In Re: Florida Power Corporation
Crystal River Nuclear Generating Plant
Docket No. 50-302

REPLY TO REQUEST FOR ADDITIONAL INFORMATION

CRYSTAL RIVER UNIT NO. 3

DOCKET NO. 50-302

WAVE ACTION STUDY,
SECTION OF MAXIMUM WAVE ATTACK
CRYSTAL RIVER UNIT 3

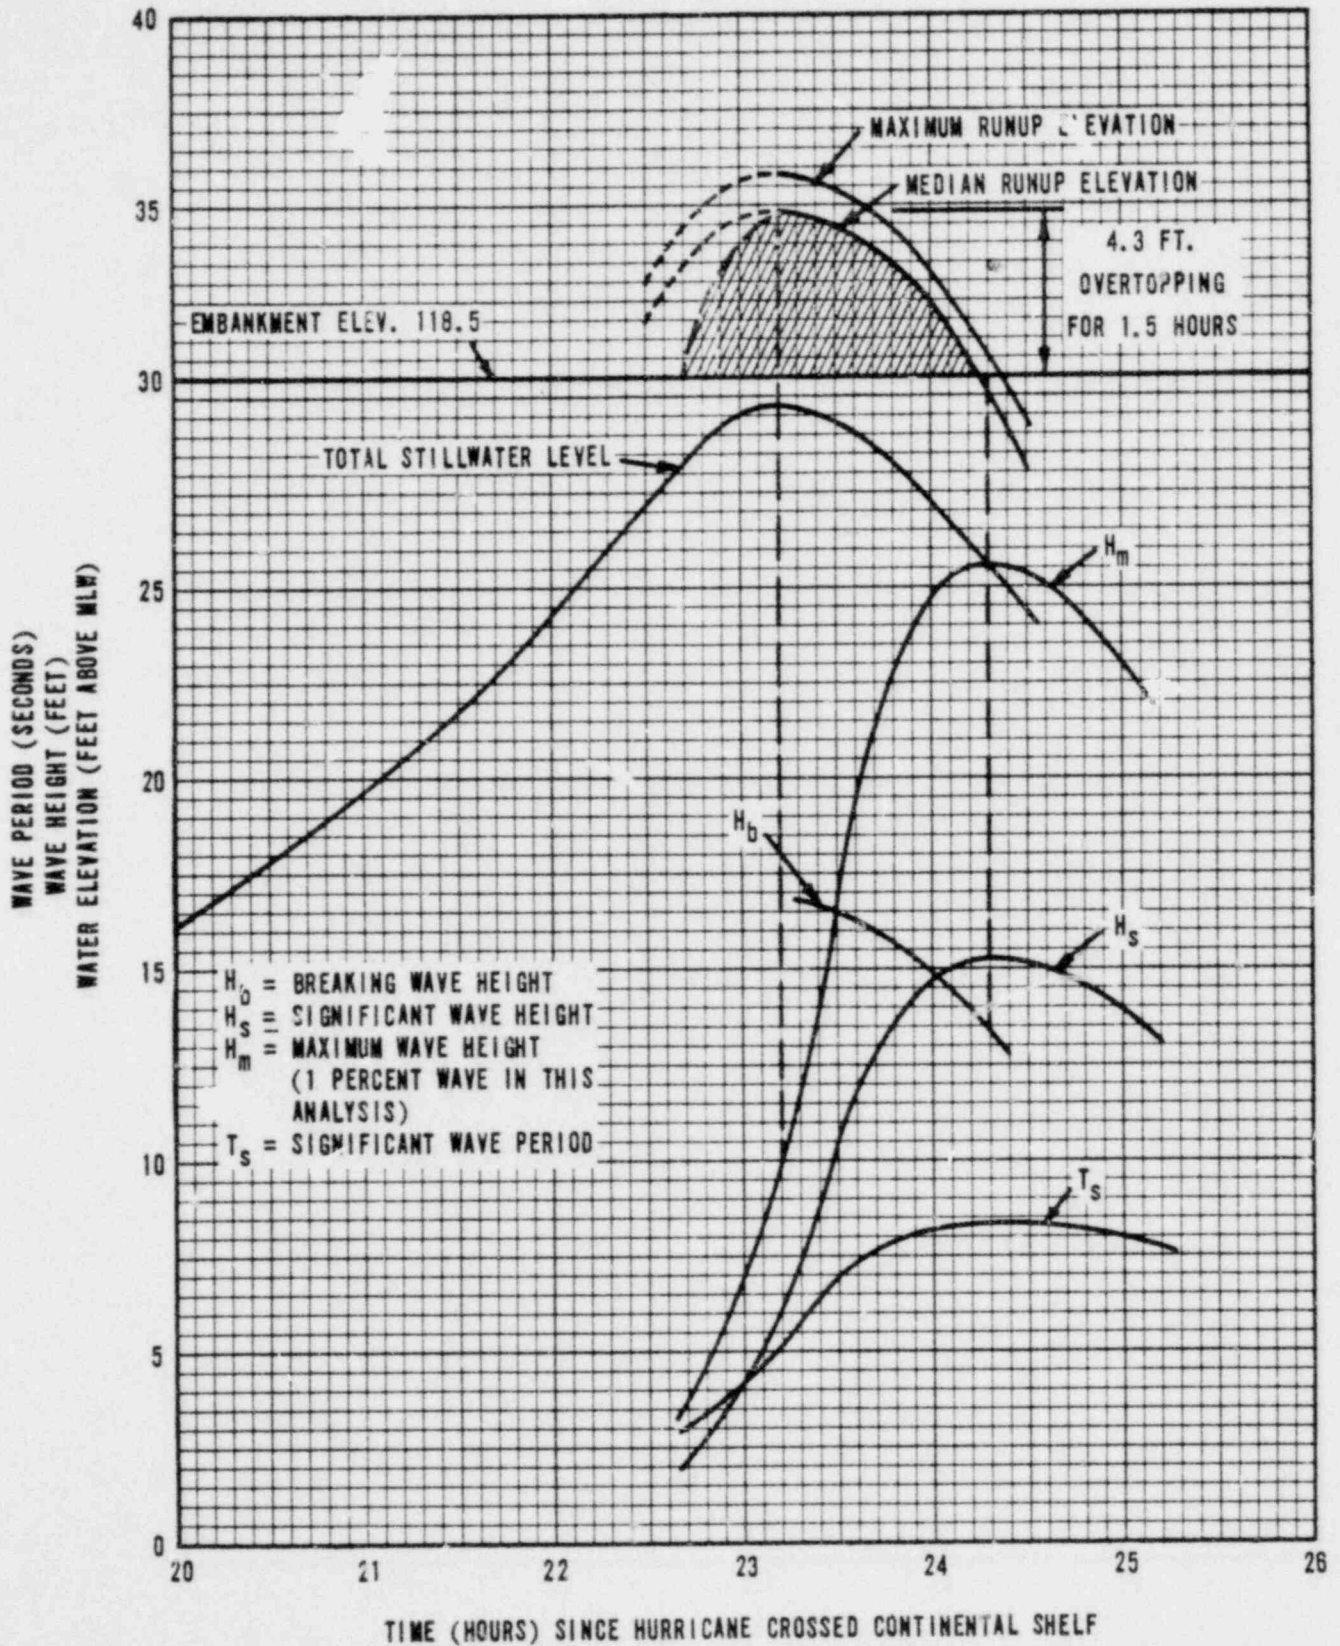
Detailed computations of the PMH surge stillwater level using probable maximum parameters and the referenced bathystrophic storm tide theory (or another method which can be substantiated), a cross section along the assumed fetch, and the hurricane track.

Estimate the critical significant and maximum (one percent) wave heights and resulting runup on safety related facilities in the spectrum of waves which can be associated with the PMH.

The maximum storm tide level computed from the above parameters is at elevation 117.6 feet (MLW is at elevation 88.0). This determination considered the topography of the site along the approach path and the critical section shown on Figure 2-24. The maximum storm tide also considered a two-foot reduction due to the effects of backwater storage resulting from the extensive flooding of the surrounding countryside some five hours prior to the peak of the surge hydrograph and runoff into peripheral areas not directly affected by the hurricane surge.⁽²⁾ The site in this extreme circumstance becomes analogous to a small island in a mountain of water due to the absence of a shore barrier rising to elevation 30. The 30-foot land contour (based on the USGS datum where sea level is 0 feet) is located about 6 nautical miles inland from the site.

The soil to be utilized is crushed limestone, which when mixed with 270 lbs. of Type I cement per cubic yard of soil, is expected to have a minimum compressive strength of 2,000 pounds per square inch. The thickness of the soil cement layer is shown in Figure 2-24.
